**DOCUMENT - 2025-366T  
HELIPORT RETROFIT IMPLEMENTATION AT 13653 MCLAUGHLIN ROAD,  
CHELTENHAM, PEEL REGIONAL POLICE FACILITY  
ADDENDUM 1**

Referring to the above Document 2025-366T - Heliport Retrofit Implementation at 13653 McLaughlin Road, Cheltenham, Peel Regional Police Facility, please note the following changes:

SHEET TITLE:  
**GROUND FLOOR PLAN - NEW & DEMOLITION HVAC**

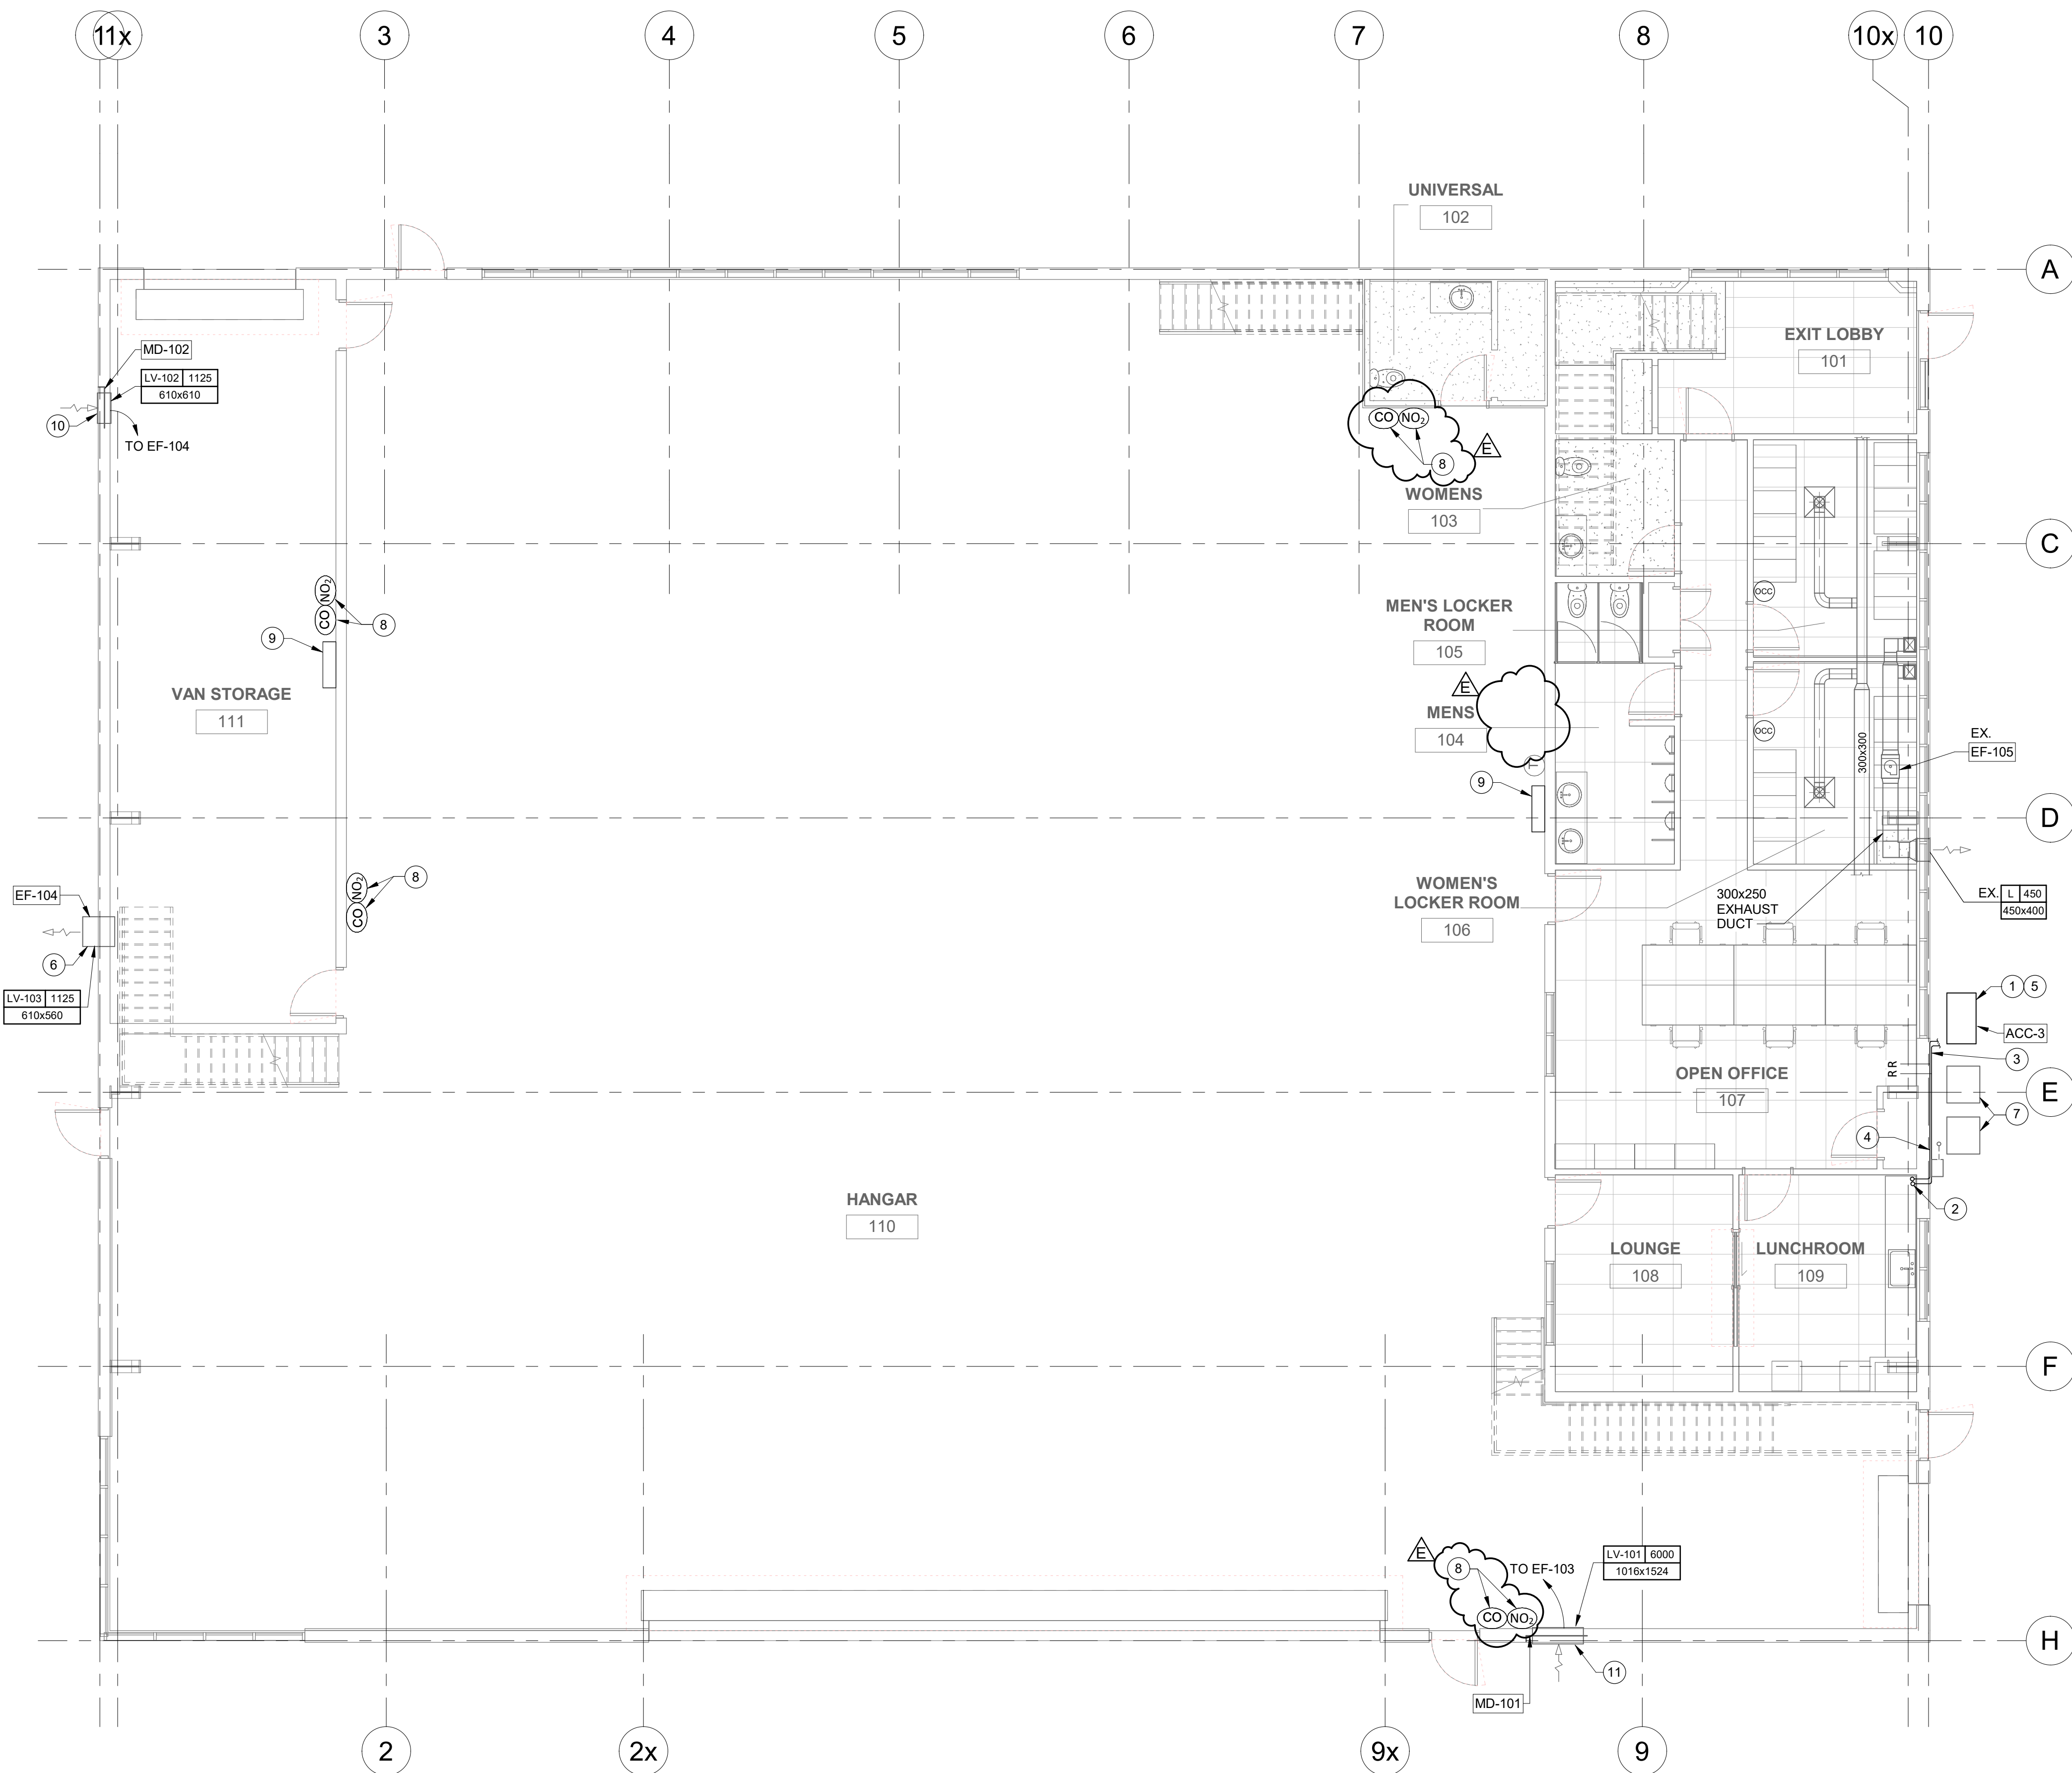
**Drawing M102**

Relocate the gas detection sensors from the north wall of the hangar area to the east wall of Washroom 102. See attached sketch for reference.

Add one set of gas detection sensors and install them on the east wall of the hangar area. Wire back to the master controller. See attached sketch for the location.
